# Access Compliance Report

## Public Rights-of-Way

Intersection ID: 50446	Main Street: HAWFIELD_WOODS_LN	Cross Street: ALICE_MCGINN_DR	Location: SE
ADA ID: D0A1E2B71BD0	Ramp Type: BlendTrans1	Initial Pass/Fail: Fail	Overall Compliance: No
Severity Score: 1.25			
Codes/Mitigation Info/Possible Solution		Field Measurements/Component Compliance

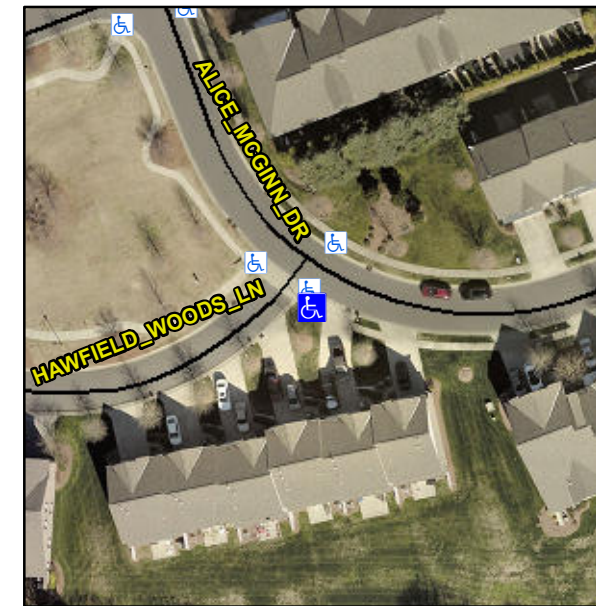
**R304.5.3**

Compliance	Description	Data	Compliance	Description	Data
N/A	Ramp Length (in)	65.0	Yes	BlendTrans Slope (%)	3.8
Yes	Ramp Width (in)	48.0	No	BlendTrans XSlope (%)	2.3
N/A	Flare Type LT	N/A	N/A	Flare Type RT	N/A
N/A	Flare Slope LT (%)	N/A	N/A	Flare Slope RT (%)	N/A
N/A	Flare Traversable LT?	N/A	N/A	Flare Traversable RT?	N/A
N/A	Landing Length (in)	N/A	N/A	DWS Provided?	N/A
N/A	Landing Width (in)	N/A	N/A	DWS Contrast?	N/A
N/A	Landing Slope (%)	N/A	N/A	DWS Length (in)	N/A
N/A	Landing X Slope (%)	N/A	N/A	DWS Full Width?	N/A
N/A	Landing Curb? (Y/N)	N/A	N/A	DWS Offset (in)	N/A
N/A	Shared Landing?	N/A			
N/A	Gutter Ponding?	N/A	N/A	Gutter Slope (%)	N/A
N/A	Gutter Lip Ht (in)	N/A	N/A	Gutter X Slope (%)	N/A
N/A	Painted X Walk1?	No	N/A	Painted X Walk2?	N/A
	X Walk 1 Direction	To NW		X Walk 2 Direction	N/A
	X Walk 1 Width (in)	N/A		X Walk 2 Width (in)	N/A
	X Walk 1 Slope (%)	3.4		X Walk 2 Slope (%)	N/A
	X Walk 1 X Slope (%)	2.6		X Walk 2 X Slope (%)	N/A

**Remove & Replace Curb Ramp With Two New Directional Ramps or Equivalent.**
